7.4 Review Comments from GNWT – Environment and Natural Resources

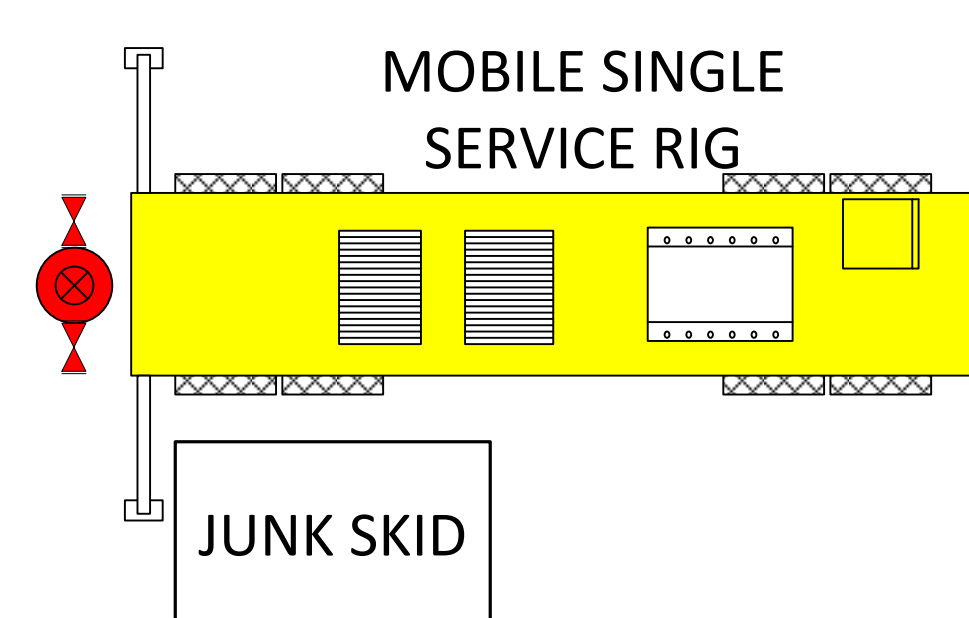
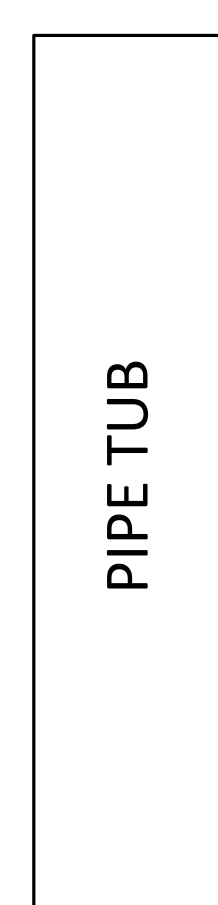
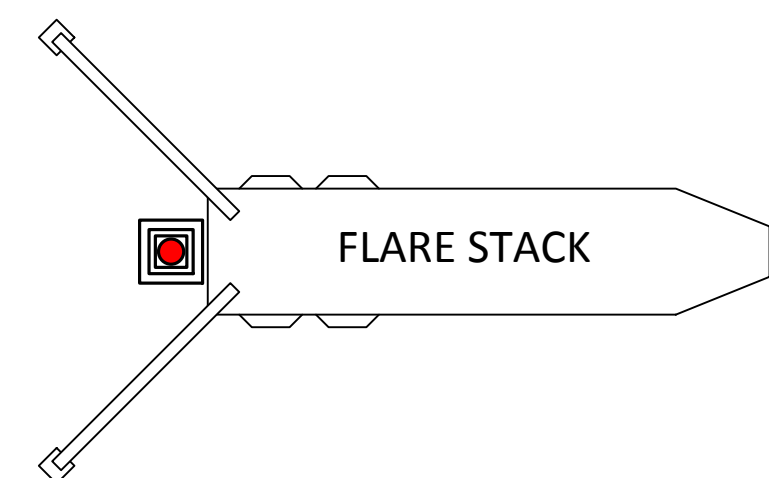
Comment: Comment(s): Section 3.3 states that tubing volume in the reservoir will be replaced with

water/methanol. It is understood from the water use information provided that only 30 m³ will be required for re-suspension activities. While the Waste Management Plan outlines that methanol will be removed by registered hazardous waste carrier it is unclear as to the ratio of water and methanol that will be injected into the well and if/how it will be recovered.

Recommendation: Recommendation: 1) ENR requests additional information on the fate, composition and quantities of material to be injected down hole during re-suspension activities as well as any mitigation measures that will be used to prevent the escape of fluids at the surface or within the wellbore.

Nov 7: The current program has Suncor pumping a 1 m³ spearhead of 100% methanol down the tubing to prevent hydrate

formation. This will be followed by $\pm 5 \text{ m}^3$ of 20% methanol / 80% water to displace the gas from the tubing. Once the new bridge plug is set and holes punched in the tubing above the packer, the frac oil in the annulus will be circulated out using $\pm 24 \text{ m}^3$ of 20/80 methanol water. This methanol water will stay in the hole.

- The Service Rig itself contains a blowout preventer, or BOP system that is capable of shutting in the well, with or without pipe in the well and the system itself is redundant, it has a hydraulic primary and Nitrogen (N₂) secondary operating system. It must meet rigid testing requirements, prior to and during any job. The BOP is installed safely on the wellhead when it is safe to do so, in this case after the permanent bridge plug is set in the tail pipe and passes both a positive and negative pressure test. At that point the well is dead and the BOP system can be installed on the well.

- The existing fluid in the annulus is a frac oil installed during the initial completion due to the permafrost. The frac oil is a non-freezing fluid. It will be removed from the well, circulated out using the rig's pump and circulation system, recovered and sent for disposal. It will be replaced with non-freezing product (Methanol 20% / water 80% mixture).

- The fluid circulating system on the Service Rig consists of a pump, high and low pressure lines and a storage tank. They are all heated and portable, pressure tested prior to use and an integral part of virtually every job the rig undertakes. Lines that are opened are drained into basins and that fluid disposed of.

- No well testing is planned so there will be no fluids or gasses exiting from the well.

TITLE	TYPICAL WELLSITE LAYOUT
DESCRIPTION	SUNCOR ENERGY SERVICE RIG WITH P-TANK
REVISED	11/7/2014
DRAWN BY	M.J. CASSIDY

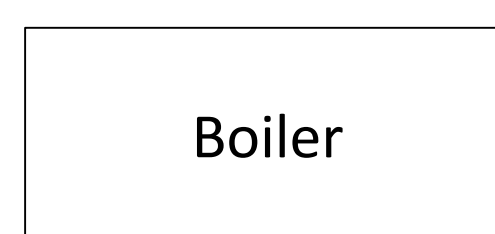
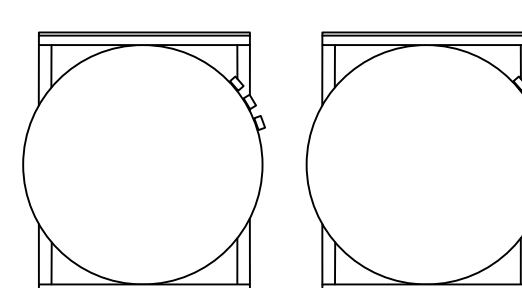
Recommendation: Recommendation(s):
1) A detailed description and sketch of the storage layout and drainage should be provided.

Recommendation: The main objective of this regulation is to prevent any contamination of the surrounding area from storage tank systems located within the well site. The Board should ensure proponents utilize secondary containment, such as double walled tanks or bermed areas with impermeable liners for above ground storage facilities to protect the environment from spills. A detailed sketch of primary and secondary containment is required prior to

Waste Management Plan - 5.3 Handling and Storage | Comment: Comment(s): Hazardous and non-hazardous waste will be stored in a safe and secure manner and in accordance with the following: Waste materials will not be stored on the surface ice of water bodies or within 100 meters (m) of the normal high water | Nov 7: A site sketch has been attached under comment 1. Suncor will use double-walled tanks to store the fluids on-site. |

Nov 7: A site sketch has been attached under comment 1. The site sketch has been added to Attachment A of the WMP.

Nov 7: A site sketch has been attached to comment 1. All above ground storage tanks for downhole and waste fluids will be doubled walled to prevent site contamination. The site sketch has been added as an attachment to the SCP.
